# Access Compliance Report

## Public Rights-of-Way

### (Curb Ramps)

Intersection ID: 43204	Main Street: PLANTAIN_CT	Cross Street: SPEEDWELL_CT	Location: NW
ADA ID: 0D99B65DF9D5	Ramp Type: PerpDiag	Initial Pass/Fail: Fail	Overall Compliance: No
		Severity Score: 10

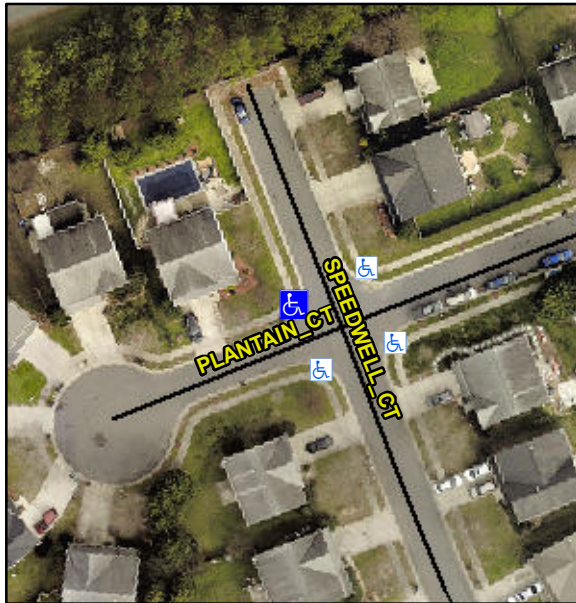
**Not Found, R304.5.1, R304.5.3**

Compliance	Description	Data	Compliance	Description	Data
N/A	Ramp Length (in)	50.0	Yes	Ramp Slope (%)	6.9
No	Ramp Width (in)	41.0	No	Ramp XSlope (%)	4.8
N/A	Flare Type LT	N/A	N/A	Flare Type RT	N/A
N/A	Flare Slope LT (%)	N/A	N/A	Flare Slope RT (%)	N/A
N/A	Flare Traversable LT?	N/A	N/A	Flare Traversable RT?	N/A
N/A	Landing Length (in)	N/A	N/A	DWS Provided?	N/A
N/A	Landing Width (in)	N/A	N/A	DWS Contrast?	N/A
N/A	Landing Slope (%)	N/A	N/A	DWS Length (in)	N/A
N/A	Landing X Slope (%)	N/A	N/A	DWS Full Width?	N/A
N/A	Landing Curb? (Y/N)	N/A	N/A	DWS Offset (in)	N/A
N/A	Shared Landing?	N/A			
N/A	Gutter Ponding?	N/A	N/A	Gutter Slope (%)	N/A
N/A	Gutter Lip Ht (in)	N/A	N/A	Gutter X Slope (%)	N/A
N/A	Painted X Walk1?	No	N/A	Painted X Walk2?	No
	X Walk 1 Direction	To S		X Walk 2 Direction	To E
N/A	X Walk 1 Width (in)	N/A	N/A	X Walk 2 Width (in)	N/A
	X Walk 1 Slope (%)	3.8		X Walk 2 Slope (%)	3.8
	X Walk 1 X Slope (%)	4.8		X Walk 2 X Slope (%)	4.6

**Remove & Replace Curb Ramp With Two New Directional Ramps or Equivalent.**
